**EPA Comments for the
Draft Pre-CMS Data Collection Work Plan dated April 5, 2021
Former Rhone Poulenc Facility, WAD 00928 2302**

**EPA Comments for the
Revised Quality Assurance Project Plan - Draft Pre-CMS Data Collection, dated April 5, 2021
Former Rhone Poulenc Facility, WAD 00928 2302**

Work Plan Comment 25 Background Information

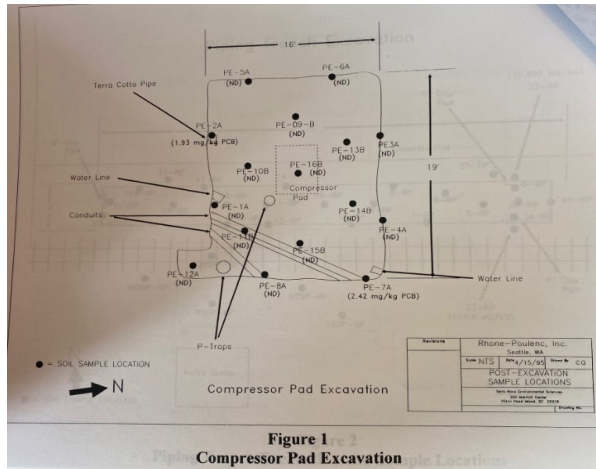
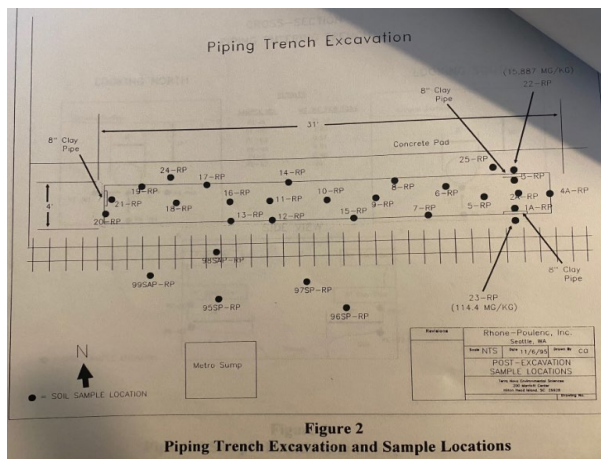
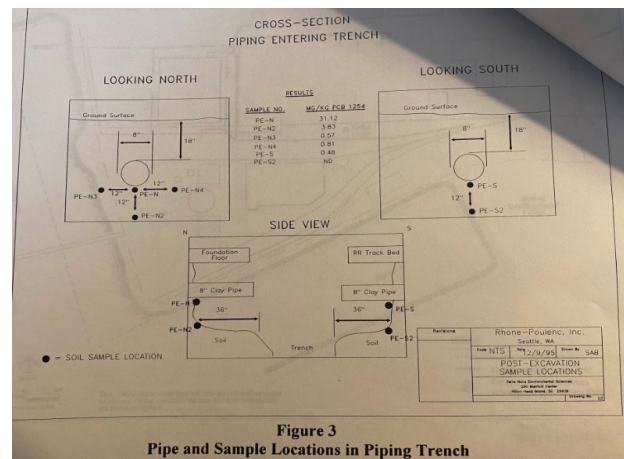
25		Figures 3 and 4		EPA appreciates the addition of the figures showing historic structures with the monitoring wells and other features. In Figure 4, the difference between the purple and pink shading is unclear. Add both to the legend. Per the 1998 Interim Measures Report, the location of the PCB excavation was near the south side of the autoclave building (#14 on historical maps, Figures 3 and 4) not the compressor pad (#18/19 on historical maps, Figures 3 and 4). Adjust the figure accordingly.	The two colors were initially used in Figure 4 because two areas overlapped. Shading has been modified and added to the legend per the comment. With regards to the location of the PCB excavation - we reviewed the 1998 report and also a 2004 Geomatrix report that pulled various historical maps together. See attached summary and historical maps.	Accepted As we discussed, the 1998 report causes confusion because of a lack of proper mapping, and the use of building names is adding to this confusion. EPA accepts DOF's interpretation of the excavation locations based on in-depth research of historical information. The location of the excavation at the compressor pad instead of the autoclave building does not affect the locations selected for PCB sampling in this Pre-CMS work plan. DOF has offered to include additional information with this spreadsheet about App IX groundwater sampling in Round 1 at 8 locations

The April 8, 1998 Interim Measures Report prepared for Rhodia Figure 1 shows the Compressor Pad Excavation and the locations of samples PE-2A and PE-7A with PCB concentrations of 1.93 mg/kg and 2.42 mg/kg, respectively. Those sample locations PE-2A & PE-7A are also shown on Figure 2-4 (Soil Sample Location Map) of the November 2004 Geomatrix Draft Corrective Measures Study Uplands in relation to historical buildings. The location of this excavation is shown to be on the northwest corner of location 19 on Figures 3 & 4 of the Draft Pre-CMS Data Collection Work Plan, historically referred to as the Compressor Shed.

The 1998 Rhodia report also provides locations of samples related to the piping trench excavation (Figures 2 & 3). Figure 3 specifically shows residual PCB location PE-N with a PCB concentration of 31.12 mg/kg on the northern sidewall below the 8" clay pipe. This excavation area is shown on Figure 2-4 of the 2004 Geomatrix document mentioned above. The excavation is shown to be located on the southeast corner of building 15, historically known as the Oil Storage Area, which is connected to the Autoclave Building (Location 14 on Figures 3 & 4 of the Pre-CMS Data Collection Work Plan).

Based on these historical maps, the PCB compressor pad excavation was shown in the Draft Pre-CMS Data Collection Work Plan near location 19 and the PCB Piping Trench Excavation near locations 14/15.
